NEENAH PLAN COMMISSION - AMENDED

DATE: February 9, 2024
TO: Mayor Lang and Plan Commission
FROM: Brad Schmidt, AICP, Deputy Director
RE: Site Plan Review – 2455 Schultz Drive – Edgewater Door

RE: Site Plan #3-24 - 2455 Schultz Drive - Edgewater Door Building Site Plan - Major Review () Status Conditional

Re: Site Plan Review

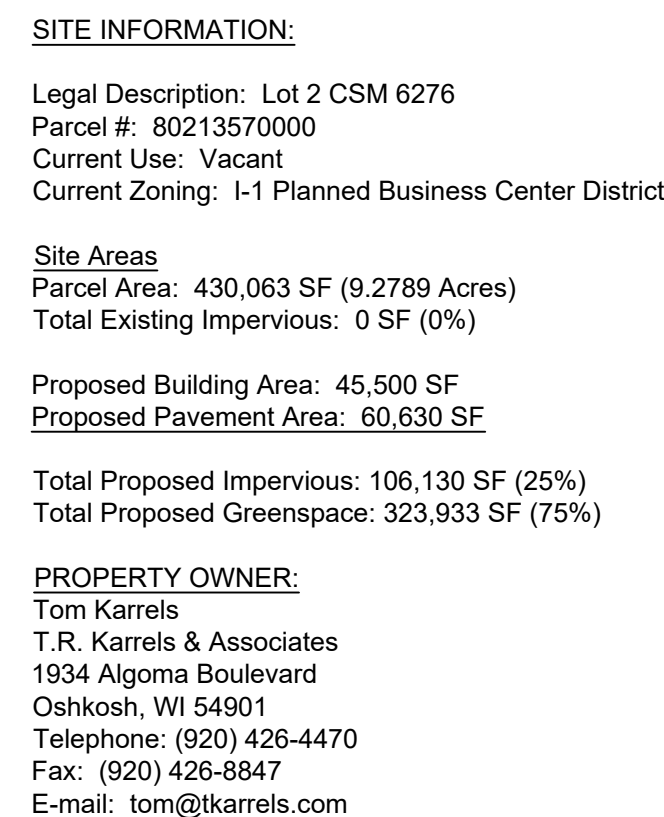
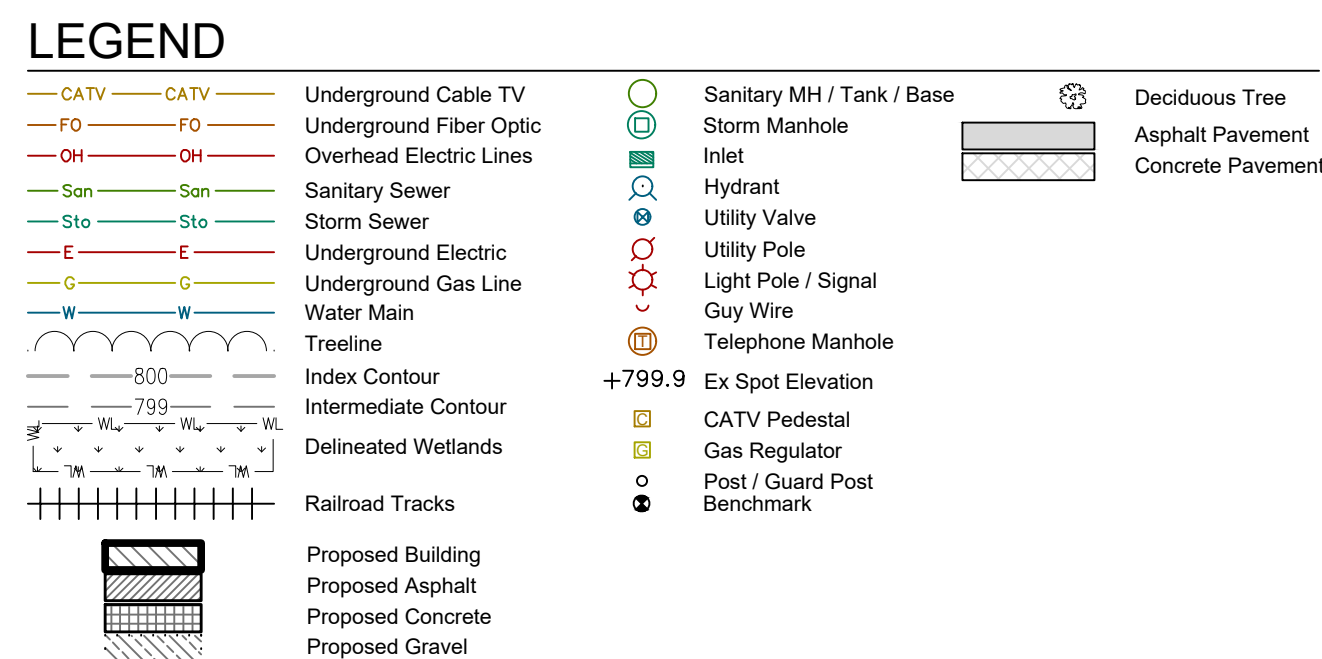
12. Fire apparatus access roads must comply with Section 503 of the 2024 International Fire Code. This includes, but is not limited to, the following:
 - a. 503.1.1 Must extend to within 150 of all portions of the facility.

This is in reference to the proposed driveway on the north side of the property. Since it is in excess of 150 feet, a turn-a-round needs to be installed.

13. John Kieckhafer, with Tom Karrels and Associates contacted me about regarding the location of the FDC and private hydrant as shown on page C1.5 of the submitted plans. Mr. Kieckhafer verified that the correct location of the FDC and private hydrant would be located on the north wall in the northeast corner of the maintenance area as shown on page A1.1 of the documents submitted.
14. Based on the way the building is laid out on the plans, it appears that there may be a chance that the building may be added on to in the future. It would be highly recommended to install additional fire hydrants around the perimeter of the building at this time, at locations to be agreed upon with NMFR and the property owner.

PROJECT INFO:
SITE PLAN
NEW BUILDING
for
DGEWATER DOOR
2455 Schultz Drive
Neenah, WI

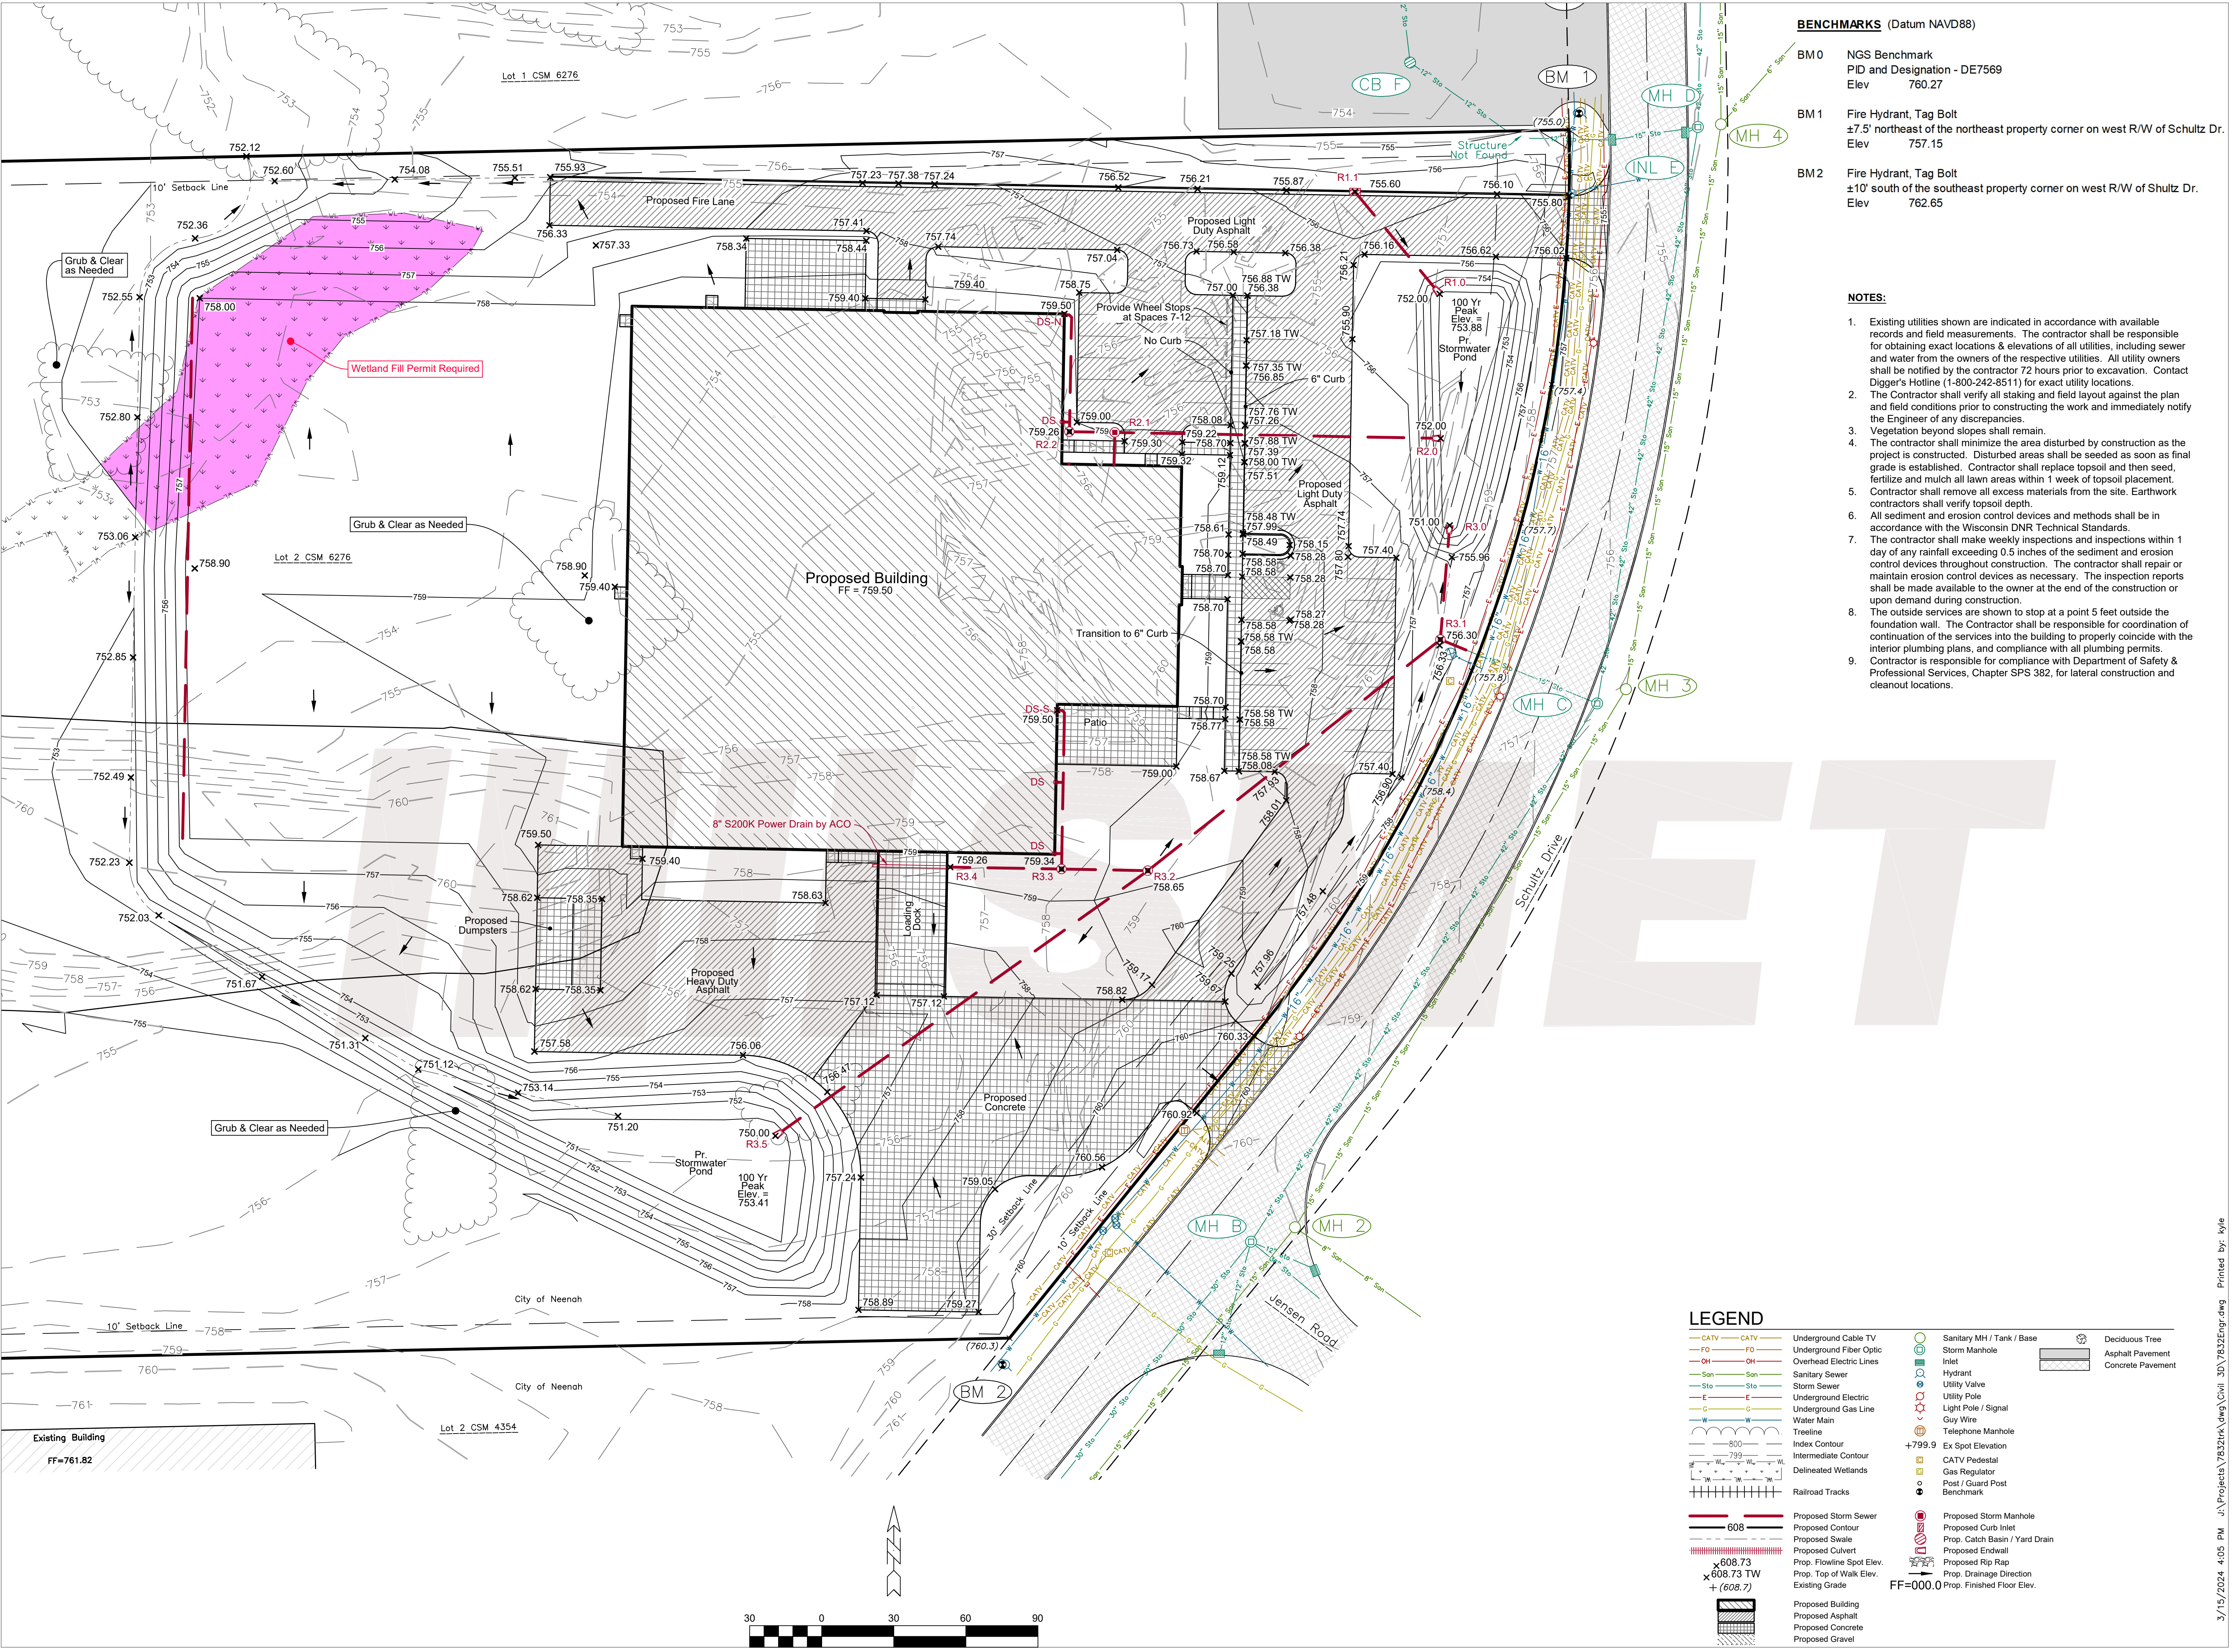
1. Provide details on the type of screening around the dumpster area south of the building. A minimum 6-foot tall sight-tight fence or landscaping plantings at least 6 feet tall shall be installed to provide screening from the south and east portions of the dumpster area.
